DISTRICT OF SAANICH

**Report To:** MAYOR AND COUNCIL  
**Date:** OCTOBER 22, 2009  
**From:** ANNE TOPP, ACTING DIRECTOR OF PLANNING  
**Subject:** SUBDIVISION/REZONING APPLICATIONS  
**Files:** SUB00596; REZ00439 - 5087 & 5093 LOCHSIDE DRIVE

**PROJECT: TO REZONE FROM RS-18 TO RS-12 AND RS-8 TO CREATE ONE ADDITIONAL LOT FOR SINGLE FAMILY DWELLING USE**

Figure #2: Tentative Subdivision

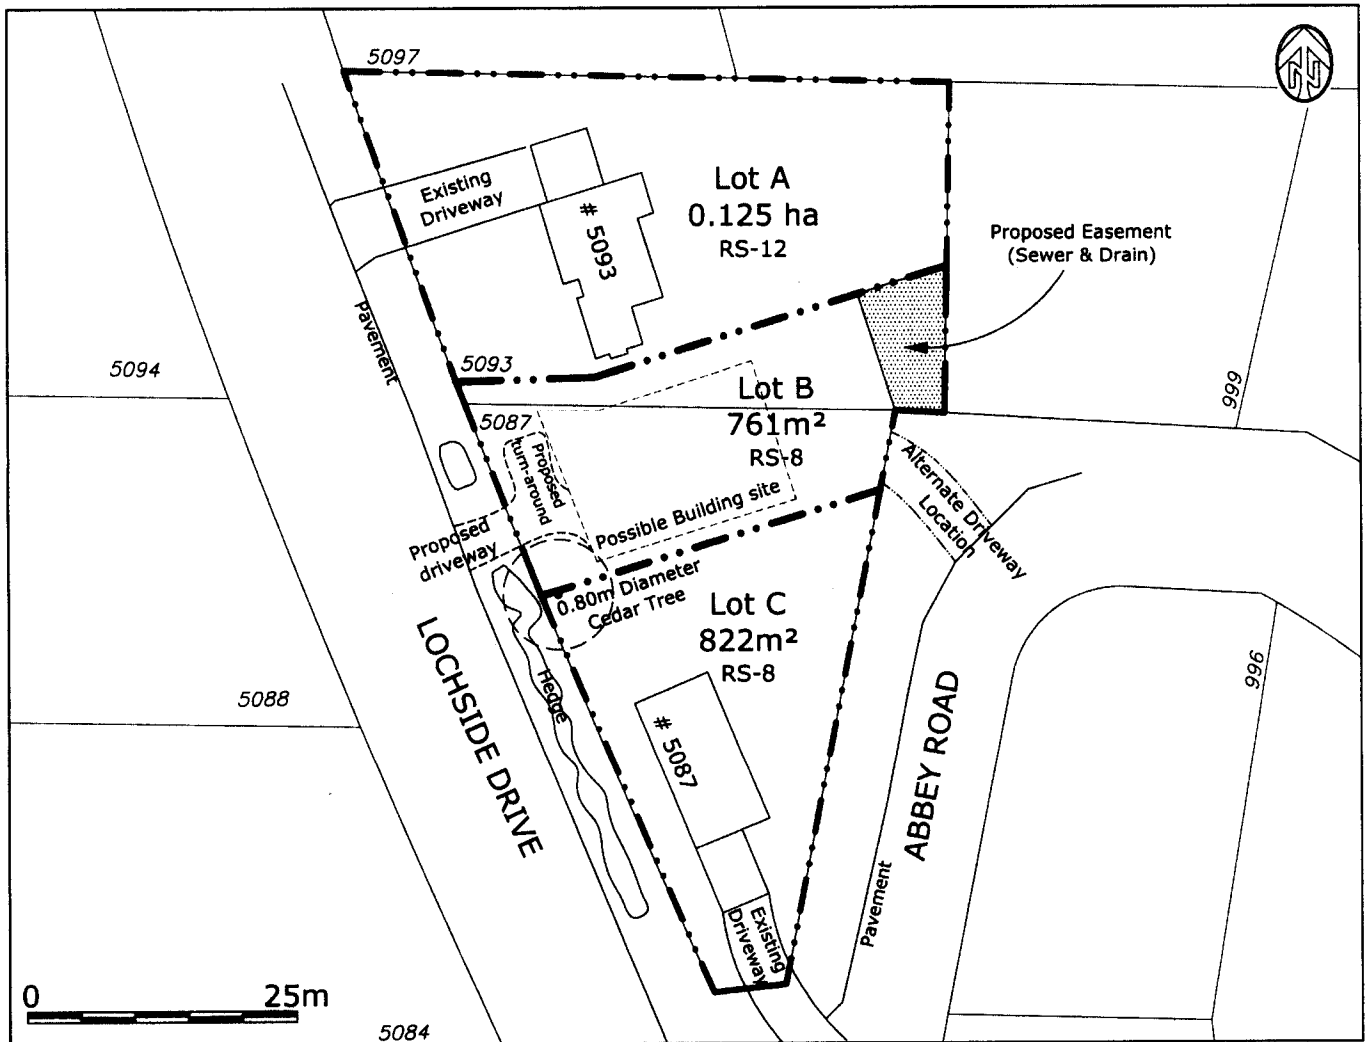
The vegetation along the Lochside Drive is a significant feature of the streetscape and recognized in the Lochside Drive Action Plan. The applicant's site plan shows potential Lot B driveway locations from both Lochside Drive and Abbey Road; however the owners would prefer access from Lochside Drive leading to a building site on the westerly portion of the lot. The proposed driveway is located where there is a gap in the existing boulevard vegetation. Where possible, servicing corridors should follow the driveway alignment. Additionally, one Boulevard Street Tree would be required as specified in Schedule "I" of the Subdivision Bylaw.

Restricting the proposed Lochside Drive access location and requiring an on-site turning area, as shown on the tentative plan (Figure #2), would maintain the street character provided by the vegetation along the Lochside Drive Boulevard. The proposed on-site turning area is intended to eliminate backing movements onto the street and should minimize impacts to trail users and local neighbourhood traffic. A suitable covenant, respecting driveway location and required on-site turning area, could be considered in the subdivision process.

ROAD - 2. IT IS RECOMMENDED THAT DRIVEWAY TO PROPOSED LOT B BE CONSTRUCTED FROM ABBEY ROAD. IF THE DRIVEWAY IS PROVIDED FROM LOCHSIDE DRIVE THEN IT MUST BE DESIGNED TO ACCOMMODATE FUTURE ROAD/TRAIL IMPROVEMENTS INCLUDING THE CONSTRUCTION OF ON-SITE TURNING AREA.

- Provision of a suitable covenant to restrict the proposed Lochside Drive access location and width, and to require the provision of an onsite turning area as shown on the tentative plan of subdivision.
